Title - Sujet Steveston (Gulf) Re-Dredging	
Solicitation No. - N° de l'invitation F1571-165032/A	Amendment No. - N° modif. 002
Client Reference No. - N° de référence du client F1571-165032	Date 2016-08-25
GETS Reference No. - N° de référence de SEAG PW-\$PWY-033-7845	
File No. - N° de dossier PWY-6-39118 (033)	CCC No./N° CCC - FMS No./N° VME
Solicitation Closes - L'invitation prend fin at - à 02:00 PM on - le 2016-08-30	
Time Zone Fuseau horaire Pacific Daylight Saving Time PDT	
F.O.B. - F.A.B. Plant-Usine: <input type="checkbox"/> Destination: <input checked="" type="checkbox"/> Other-Autre: <input type="checkbox"/>	
Address Enquiries to: - Adresser toutes questions à: Siopongco, Philip PWY	Buyer Id - Id de l'acheteur pwy033
Telephone No. - N° de téléphone (604) 351-6139 ()	FAX No. - N° de FAX () -
Destination - of Goods, Services, and Construction: Destination - des biens, services et construction: DFO - Steveston Gulf Site - Steveston, BC

Addendum 002

The following changes/clarifications in the tender documents are effective immediately.

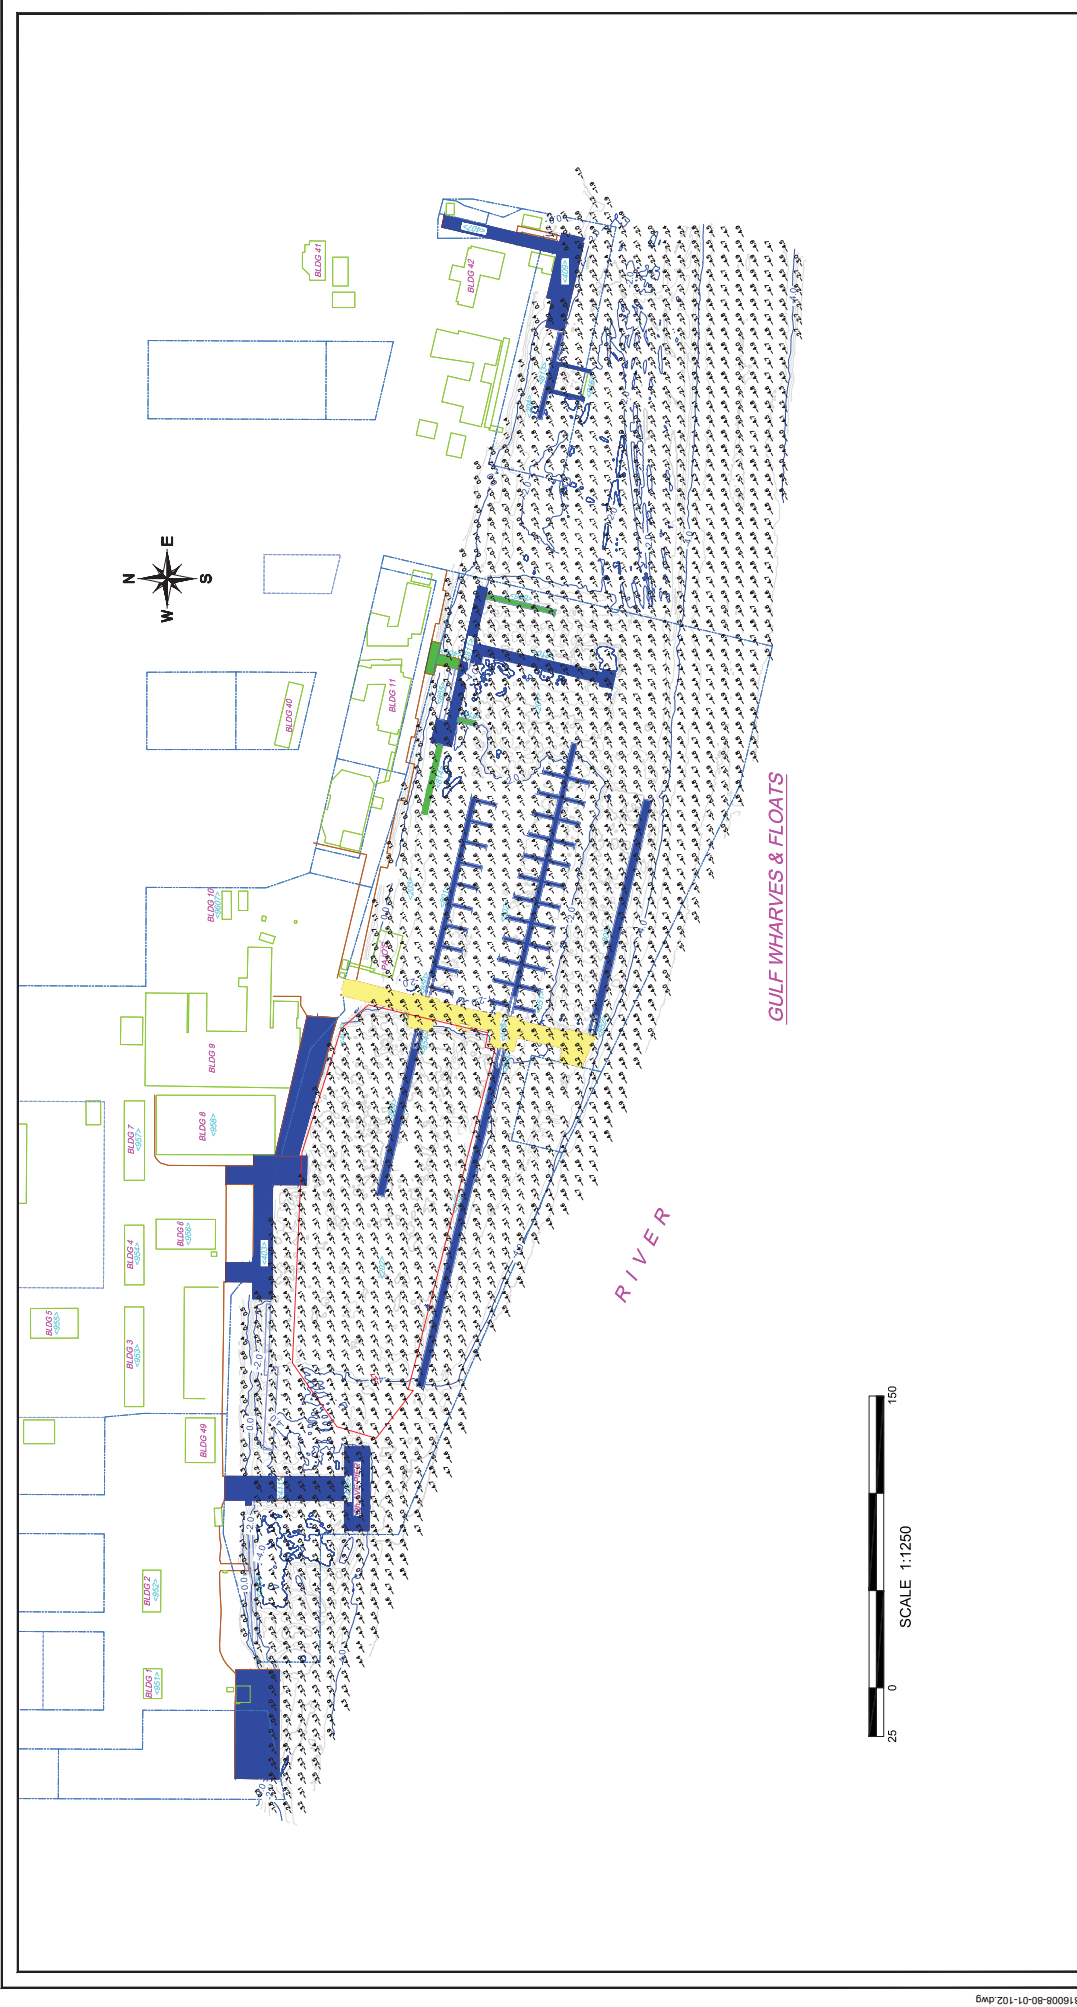
Q1) Will a current sounding survey of the dredge site be provided prior to the tender closing date?

A1) Yes, see attached sounding survey 316008-80-01-102-ISO A1 Survey-rlp.
